TDPL: 25-3-166

TDPL DATED: 20 Feb 01

NSN: 6665-00-778-3482

NOMEN: Filter, Orifice

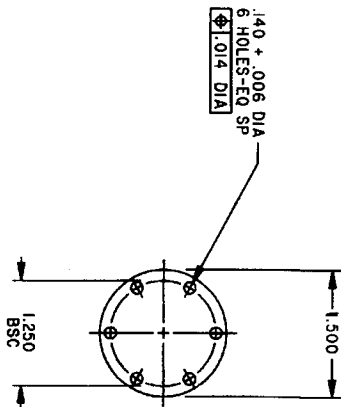
3. Drawing 25-3-166, change note 3 as follows:

From: FITER MATERIAL (ZITEC) SHEET, TEFLON 30-60 MICRON, 25.5 MILS THICKNESS, PART NO K1064-122, H4-2 MFG CODE NO. 18632

To: FITER MATERIAL (ZITEC) SHEET, TEFLON 30-60 MICRON, 18-25 MILS THICKNESS, PART NO K1064-122, CAGE CODE 18632.
